# Access Compliance Report

## Public Rights-of-Way

### (Curb Ramps)

Intersection ID: 30066	Main Street: DAY_LILLY_LN	Cross Street: SUNSET_RD	Location: E
ADA ID: 36C6119180B0	Ramp Type: Perp	Initial Pass/Fail: Fail	Overall Compliance: No
Codes/Mitigation Info/Possible Solution		Field Measurements/Component Compliance	
Severity Score: 26.25

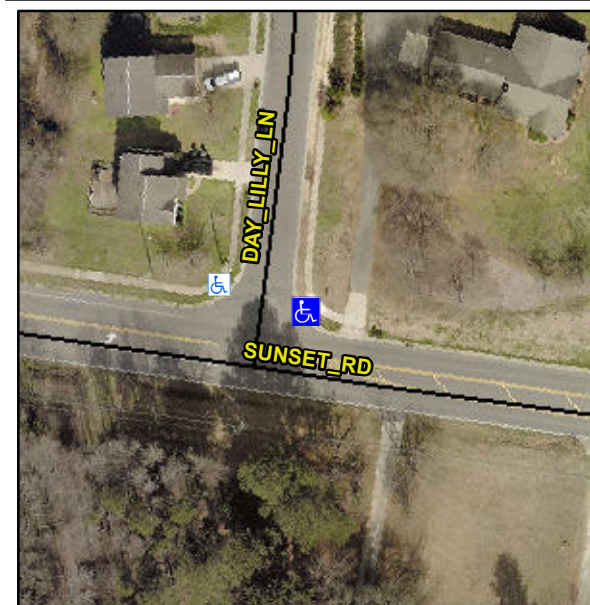
**R304.2.2, R304.5.3**

Compliance	Description	Data	Compliance	Description	Data
N/A	Ramp Length (in)	54.0	No	Ramp Slope (%)	12.7
Yes	Ramp Width (in)	48.0	No	Ramp XSlope (%)	2.2
N/A	Flare Type LT	N/A	N/A	Flare Type RT	N/A
N/A	Flare Slope LT (%)	N/A	N/A	Flare Slope RT (%)	N/A
N/A	Flare Traversable LT?	N/A	N/A	Flare Traversable RT?	N/A
N/A	Landing Length (in)	N/A	N/A	DWS Provided?	N/A
N/A	Landing Width (in)	N/A	N/A	DWS Contrast?	N/A
N/A	Landing Slope (%)	N/A	N/A	DWS Length (in)	N/A
N/A	Landing X Slope (%)	N/A	N/A	DWS Full Width?	N/A
N/A	Landing Curb? (Y/N)	N/A	N/A	DWS Offset (in)	N/A
N/A	Shared Landing?	N/A			
N/A	Gutter Ponding?	N/A	N/A	Gutter Slope (%)	N/A
N/A	Gutter Lip Ht (in)	N/A	N/A	Gutter X Slope (%)	N/A
N/A	Painted X Walk1?	No	N/A	Painted X Walk2?	N/A
	X Walk 1 Direction	To NW		X Walk 2 Direction	N/A
N/A	X Walk 1 Width (in)	N/A	N/A	X Walk 2 Width (in)	N/A
	X Walk 1 Slope (%)	4.7		X Walk 2 Slope (%)	N/A
	X Walk 1 X Slope (%)	1.6		X Walk 2 X Slope (%)	N/A

**Remove & Replace Entire Ramp.**
